Your Ref: ABP- 314232-22

**Re: Railway Order Application– Regarding the proposed DART+ West Railway Order  
- Dublin City to Maynooth and M3 Parkway**

**Figure 1: IW Abstraction Points in Close Proximity to Proposed Route**

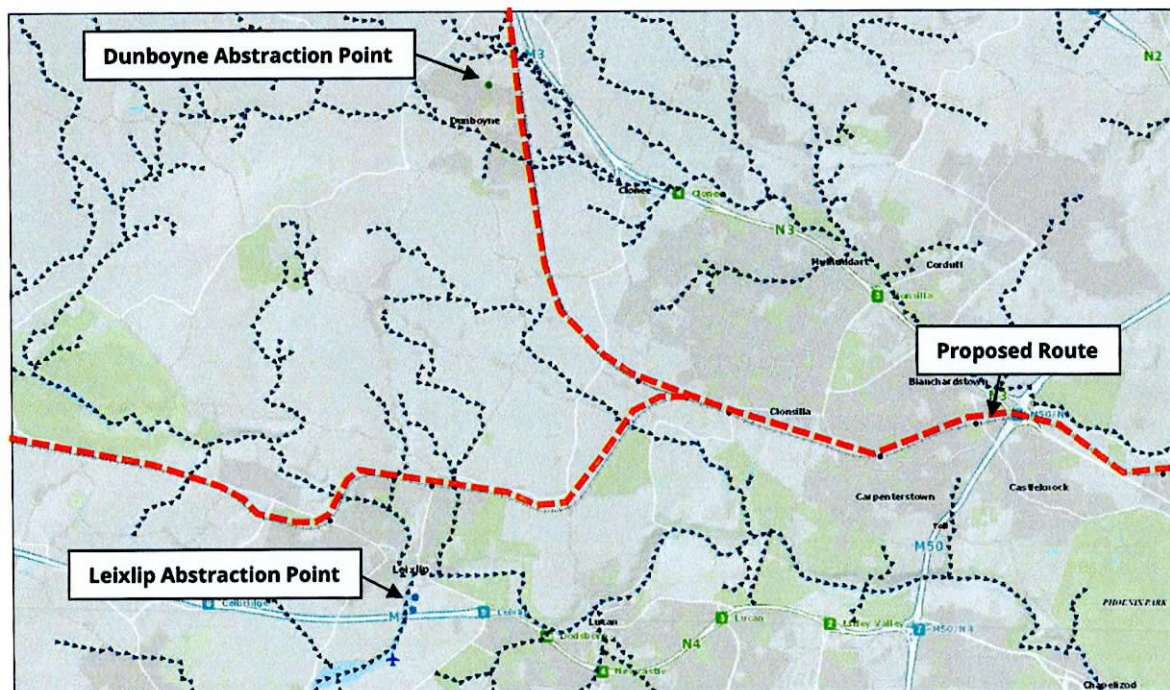
In addition to the above, the proposed development has also been assessed for any likely impacts to Groundwater Sources in close proximity to the development site. IW have reviewed the planning application site and proposed route and can confirm it passes in close proximity to the Dunboyne and Leixlip Abstraction Points, see Figure 1 below.

On assessment, it is considered that, due to the developments location downstream from the Leixlip Abstraction Point, the proposed development is not likely to have a negative impact on the Leixlip Abstraction Point.

In addition, the proposed route is located in close proximity to the Dunboyne Abstraction Point, specifically relating to the area of development immediately south of the M3 Parkway Station where works are proposed. A detailed assessment of the likely impacts of both the construction and operational phases of development, are set out in Chapter 11.5 of the applicant's EIAR.

IW acknowledges the mitigations proposed as part to the applicants EIAR, however, irrespective of the mitigations outlined in the applicant's EIAR, no deterioration of or impact to, these drinking water sources and/or abstractions shall occur at any stage of the project, either construction or operational. The applicant will be required to engage with IW to agreed all mitigation measures to protect these drinking water sources and/or abstractions prior to any works or operations commencing.

IW are satisfied that, the proposed development can be facilitated without negative impacts to the Dunboyne Abstraction Point, subject to the following;

- The developer/operator must comply with the Water Framework Directive and River Basin Management Plan objectives to ensure that the development will not negatively impact on the water quality of source/receiving waters during both construction and operational phases
- The developer/operator must meet the requirements of EIA Directive 2014/52/EU
- The developer/operator must comply with the requirements of the Groundwater Directive, Article 6(1) of Directive 2000/60/EC
